# UNITED STATES PATENT AND TRADEMARK OFFICE

APPLICATION NO.	FILING DATE	FIRST NAMED INVENTOR	ATTORNEY DOCKET NO.	CONFIRMATION NO.
09/542,897	04/04/2000	Jerry H. Chisnell	FTP141A US	5716
21133	7590	12/30/2003	EXAMINER	
VAN OPHEM & VANOPHEM, PC 51543 VAN DYKE SUITE 103 SHELBY TOWNSHIP, MI 48317-4447			PATEL, VISHAL A	
			ART UNIT	PAPER NUMBER
			3676

## Office Action Summary

### DETAILED ACTION

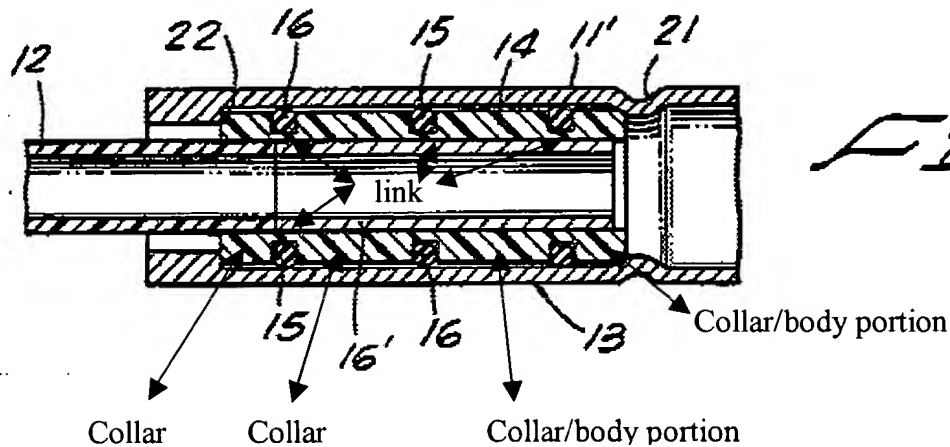
the female component includes a mounting surface and a through bore extending through the female component, the through bore having a chamfer (tapered section near 21 in contact with 14) in the mounting surface, the chamfer and the through bore defining a transition surface therebetween;

one of the plurality of collar sections engaged in annular line contact against the tapered surface to secondarily seal the fluid tight conduit connection; and

a composite sleeve seal circumscribing the male component such that the composite sleeve seal is interposed the male and female component for sealing the fluid-tight conduit connection, the composite sleeve seal comprising:

a body portion including a plurality of collar section (collar sections as shown in figure 6 below) spaced apart from one another to define at least one gap therebetween (gap between each collar),

the plurality of collar sections being interconnected by at least one link segment (link segment as shown in fig. 6 below) spanning the at least one gap;

at least one seal portion (seal portion 16) interposed the plurality of collar sections in the at least one gap and surrounding the at least one link segment to interlock the at least one seal portion with the body portion to form the composite sleeve seal as one integral component;

the plurality of collar sections are made of plastic (entire 14 is made of plastic) and the at least one seal portion is made of rubber material (o-rings are made of rubber).

Applicants' argument that Frye does not disclose "a body portion", "at least one collar", "at least one link segment", "at least one gap" and "at least one sealed portion" is not persuasive because the drawing (above figure 6) of Frye clearly shows a body at least one collar, at least one link segment, at least one gap (gaps between 12 and 13 that are sealed by 16) and at least one sealed portion. Furthermore applicant's arguments are not persuasive since all the features are clearly shown in figure 6 of Frye.
